Preliminary responses to OEH and SEWPaC comments on the Preferred Project
Report and Response to Submissions — biodiversity (26 March 2013)

Re: Cobbora Coal Project – Preliminary Responses to OEH and SEWPaC Comments on the Preferred Project Report and Response to Submissions – Biodiversity

DATE: 19/3/2013
MEMO TO: Department of Planning and Infrastructure – Stephen O’Donoghue
FROM: Gavin Heydon
SUBJECT: CLARIFICATION OF TAILINGS INFORMATION
REFERENCE:

The purpose of this addendum is to correct the results presented in Appendix E that were affected by a water balance model error, and to discuss the wider implications of the error for the Surface Water Assessment and Environmental Assessment. In addition, further information is provided in the addendum on additional model sensitivity analyses undertaken to address a concern of the DP&I's reviewer regarding the reliance of the mine on the surface water entitlement from the Cudgong river source. Specifically, the reviewer raised the concern that the volume of groundwater inflow to the mine pits available for use in the mine water management system may have been overestimated.

Figure A3.1 – Water balance for SD15 for mine stage year 4 and 90th percentile rainfall (wet) year of 1990 (plot 1 of 3)

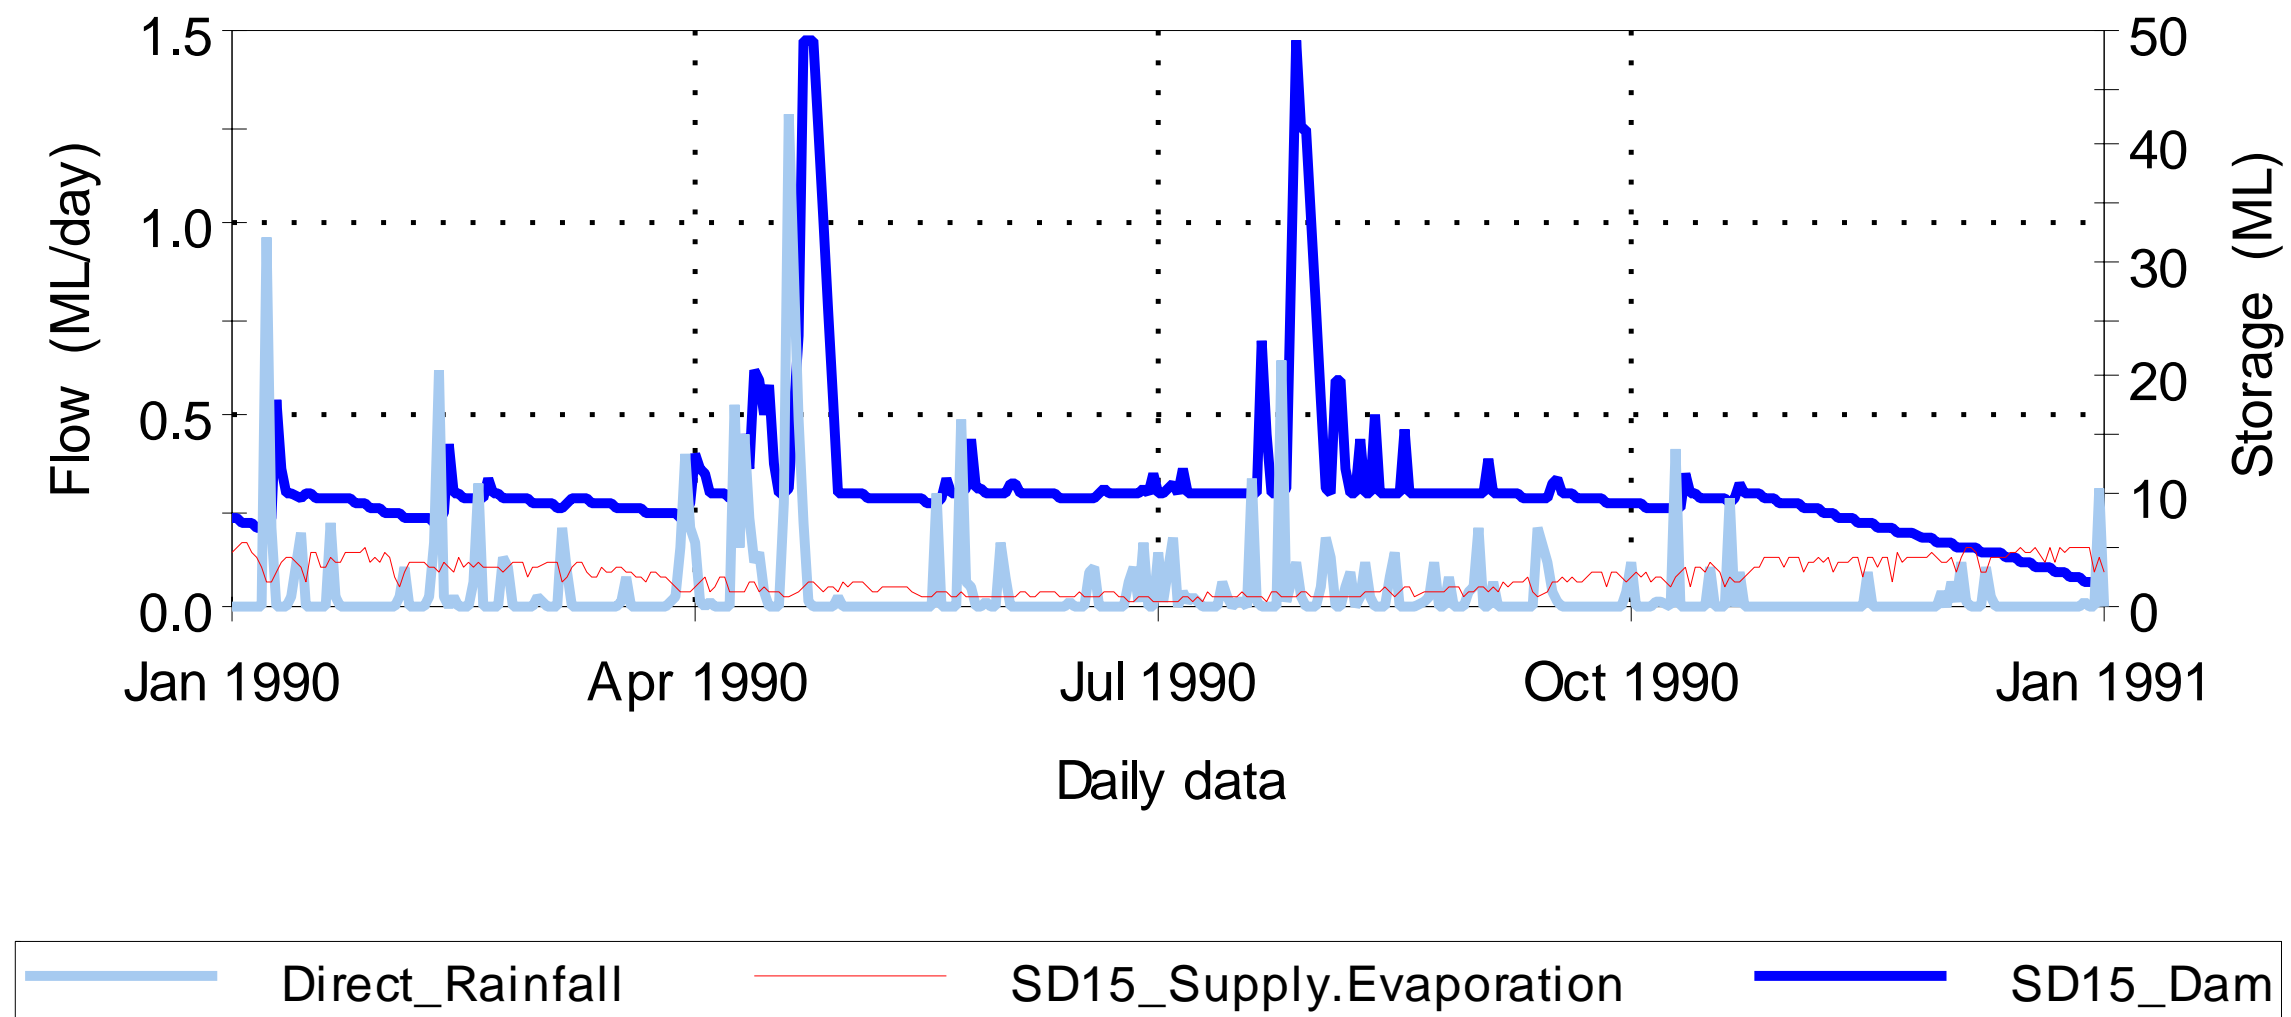
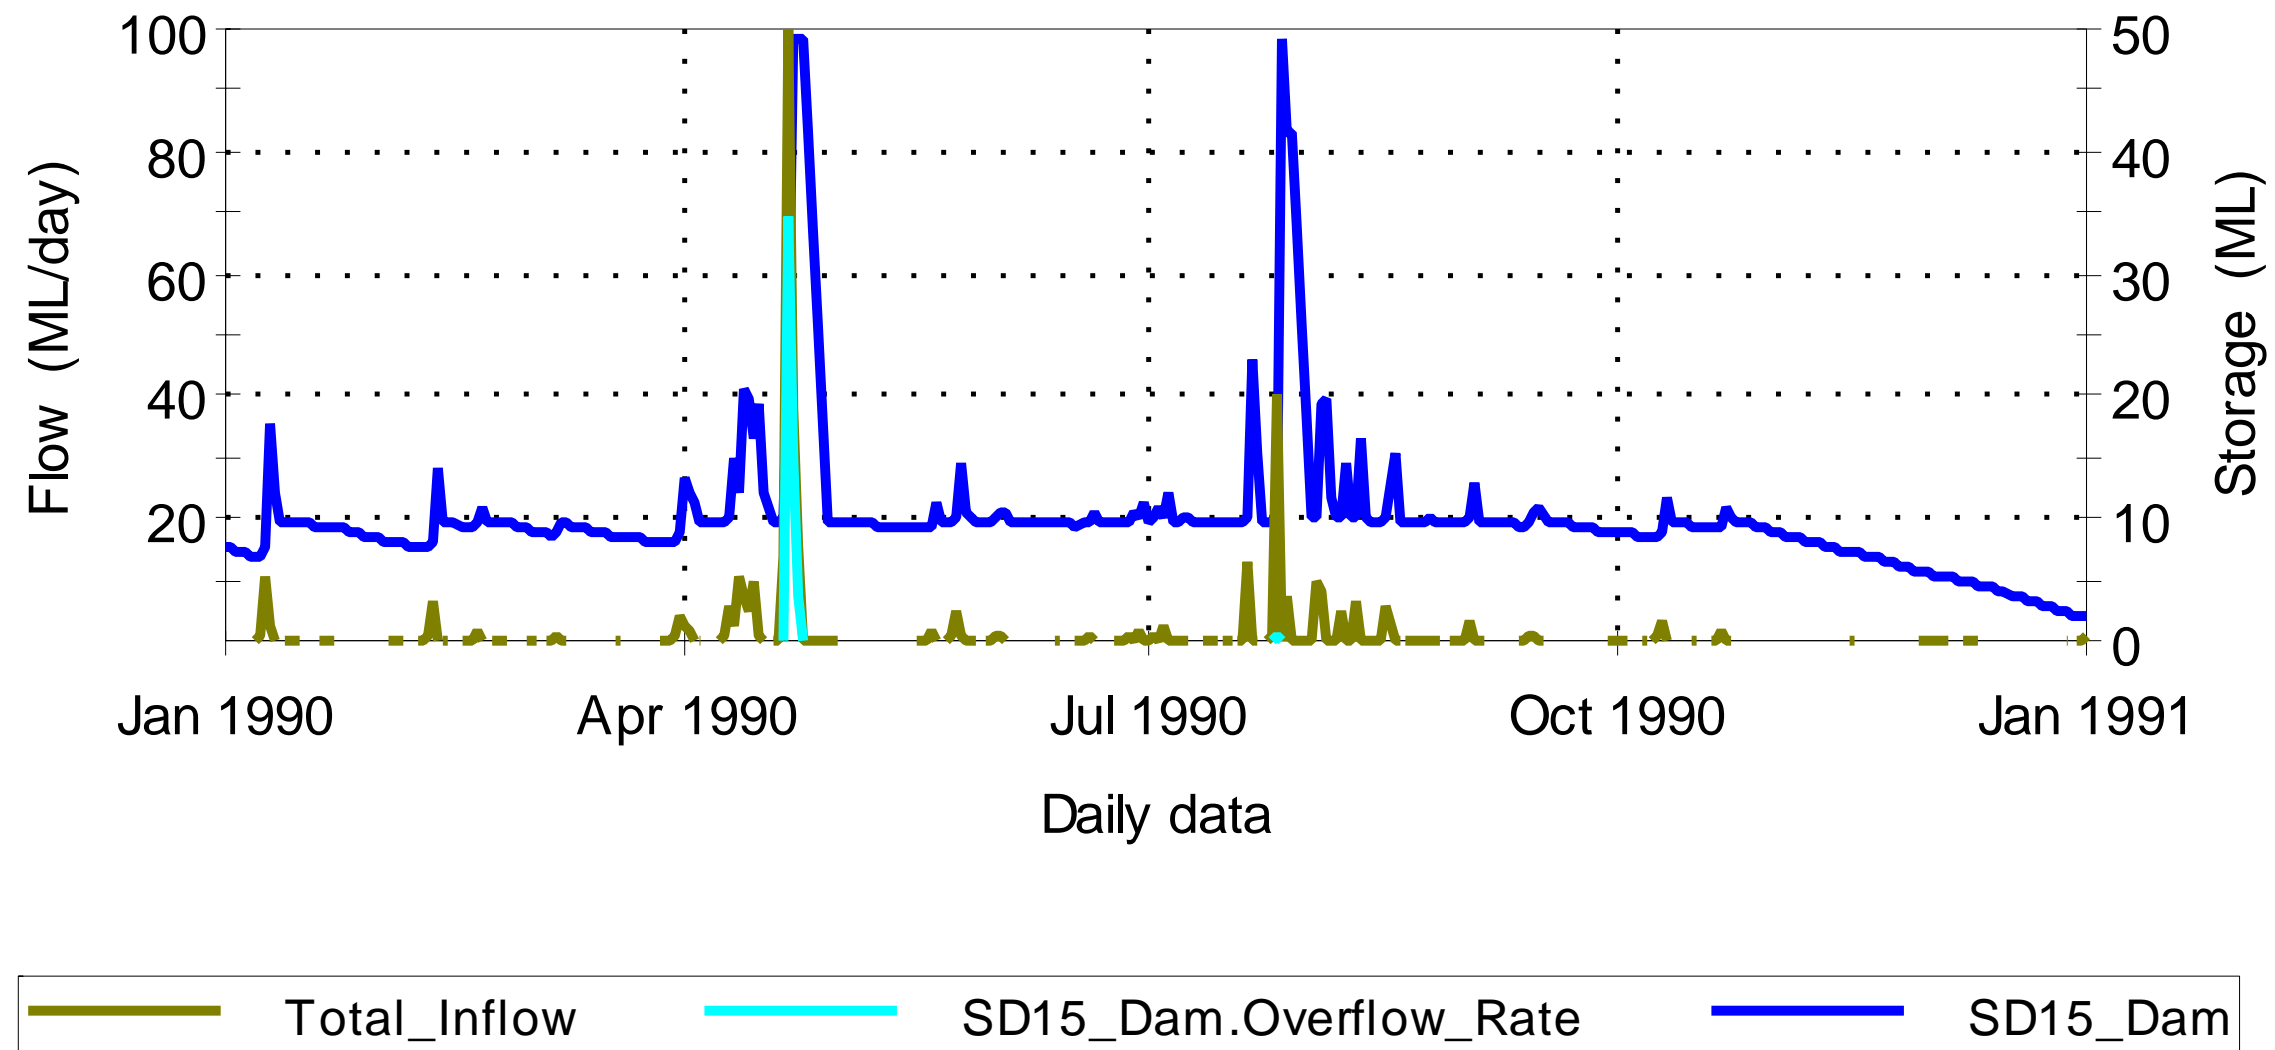
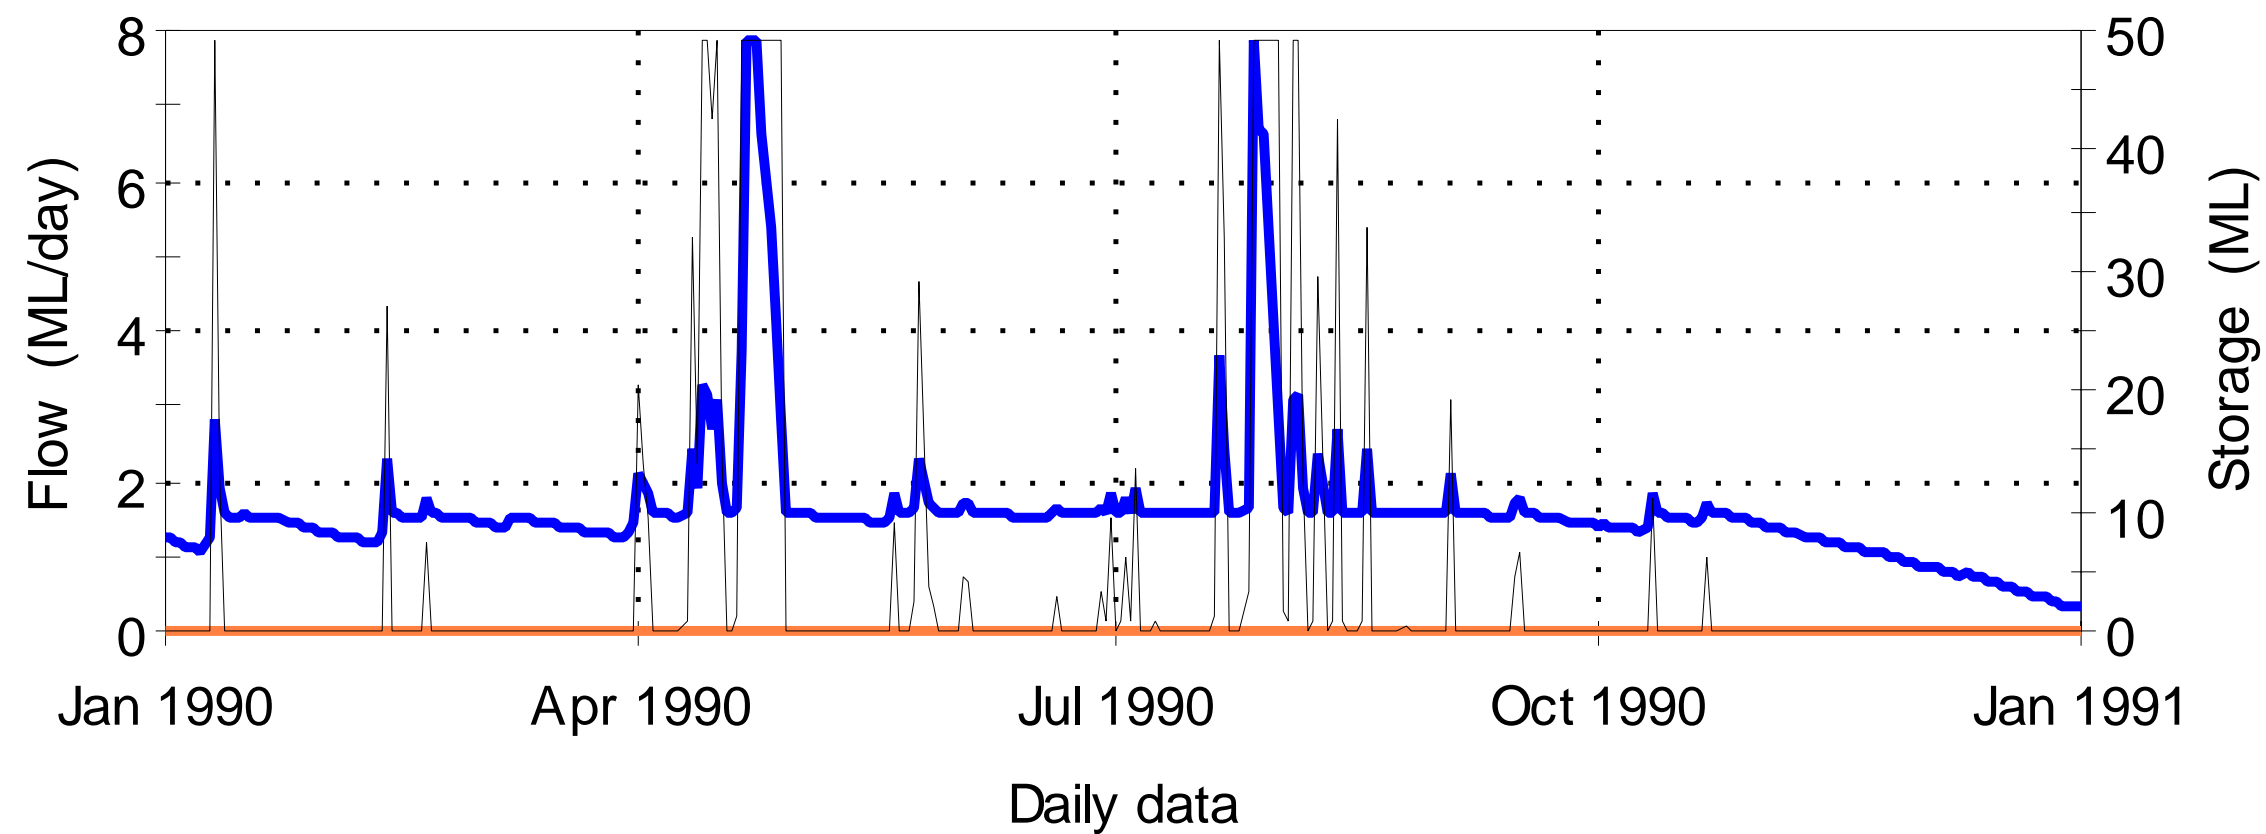
Figures A3.1 to A3.3 show the daily simulation for SD15 for 1990 (wet) conditions. The figures illustrate that overflows from an SD can occur at the same time when it is releasing water to the creek through its controlled outlets. No pumping from this dam to MWD3 was allowed as the MWD3 dam was more than 25% full.
